# Access Compliance Report

### (Curb Ramps)

Intersection ID: 10042138	Main Street: WITHERS_COVE_PARK_DR	Cross Street: N/A	Location: SE
ADA ID: 0D181C6359FE	Ramp Type: PerpDiag	Initial Pass/Fail: Fail	Overall Compliance: No
Severity Score: 22.5			
Codes/Mitigation Info/Possible Solution		Field Measurements/Component Compliance

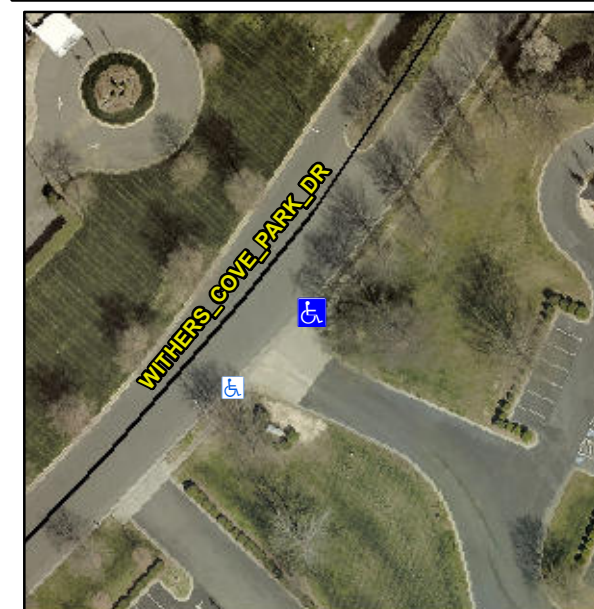
**Not Found, R304.5.1, R304.2.2, R304.5.3**

Compliance	Description	Data	Compliance	Description	Data
N/A	Ramp Length (in)	96.0	No	Ramp Slope (%)	10.1
No	Ramp Width (in)	36.0	No	Ramp XSlope (%)	3.0
N/A	Flare Type LT	N/A	N/A	Flare Type RT	N/A
N/A	Flare Slope LT (%)	N/A	N/A	Flare Slope RT (%)	N/A
N/A	Flare Traversable LT?	N/A	N/A	Flare Traversable RT?	N/A
N/A	Landing Length (in)	N/A	N/A	DWS Provided?	N/A
N/A	Landing Width (in)	N/A	N/A	DWS Contrast?	N/A
N/A	Landing Slope (%)	N/A	N/A	DWS Length (in)	N/A
N/A	Landing X Slope (%)	N/A	N/A	DWS Full Width?	N/A
N/A	Landing Curb? (Y/N)	N/A	N/A	DWS Offset (in)	N/A
N/A	Shared Landing?	N/A			
N/A	Gutter Ponding?	N/A	N/A	Gutter Slope (%)	N/A
N/A	Gutter Lip Ht (in)	N/A	N/A	Gutter X Slope (%)	N/A
N/A	Painted X Walk1?	No	N/A	Painted X Walk2?	No
	X Walk 1 Direction	To N		X Walk 2 Direction	To SW
N/A	X Walk 1 Width (in)	N/A	N/A	X Walk 2 Width (in)	N/A
	X Walk 1 Slope (%)	4.0		X Walk 2 Slope (%)	1.3
	X Walk 1 X Slope (%)	2.3		X Walk 2 X Slope (%)	3.6

**Remove & Replace Curb Ramp With Two New Directional Ramps or Equivalent.**
